***NRC comments and questions in advance
EVS19-E1TP-0600 JASIC***

Dec 3-5, 2019

19 EVS - GTR

Modified method

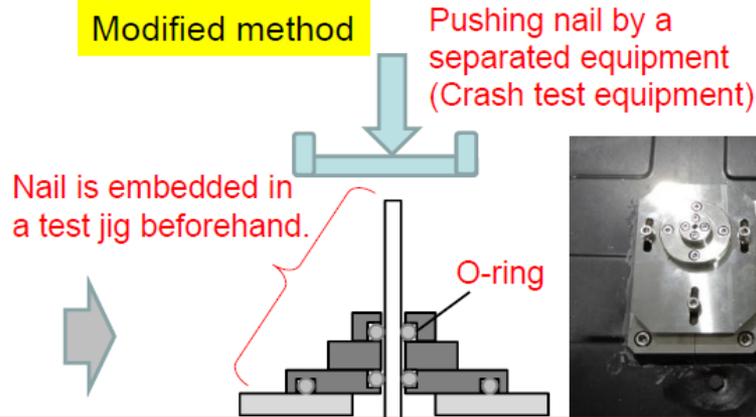
1. On the previous slide, it states no modifications as an advantage. This seems like a significant modification which would involve engineering support from the battery supplier. Modules may also need to be predrilled, depending on their design and the target location/direction.

A vehicle manufacture may purchase battery modules from a module supplier and assemble a battery pack according to its own design. In this case, the battery pack can be modified by the vehicle manufacture easily without getting help from the module supplier. It is a great benefit for vehicle manufactures to conduct tests.

■ Test setting and results

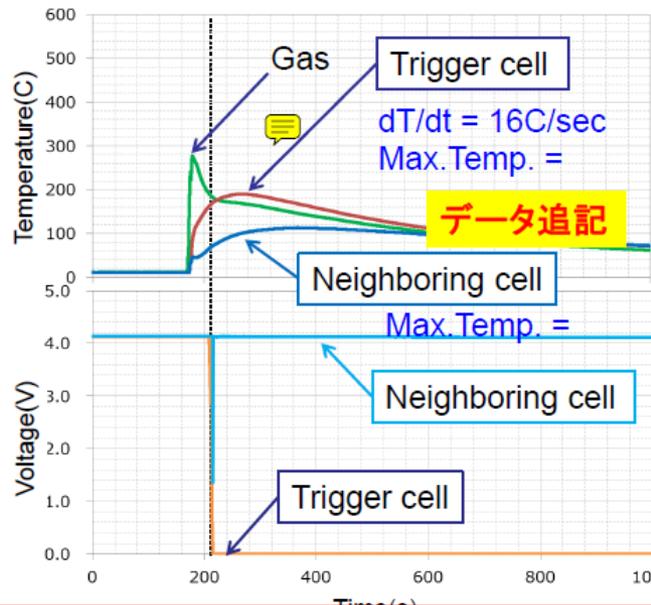
2. Nail penetration direction appears to be downward from the top of the pack. How could this approach be applied at the vehicle level? What if a pack design has cells which are oriented such that up/down is parallel to the electrodes?

Nail penetration direction needs to be vertical to the electrodes. Nail penetration in a horizontal direction is necessary depending on situations. Depending on the pack or vehicle design, the nail method may not be feasible.

Temperature measurement point

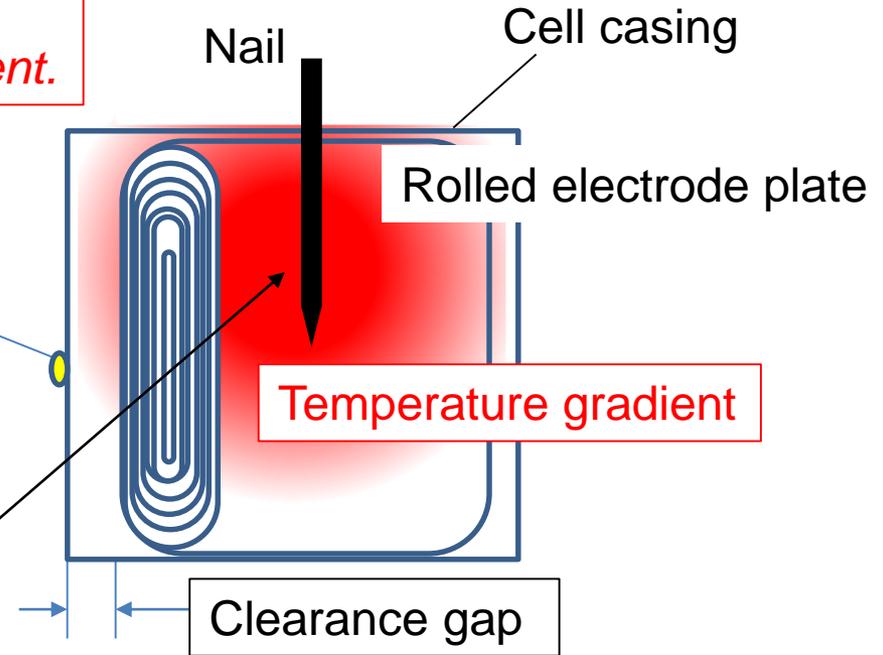
3. From the graph, the peak temperature of the trigger cell appears to be 200C. Can you please explain why this value is so low?

*Probable cause of the low peak temperature
→ A clearance gap and a temperature gradient.*

<Presumption>

Temp. inside electrodes > around 250 C

Onset temperature for thermal decomposition of positive electrode
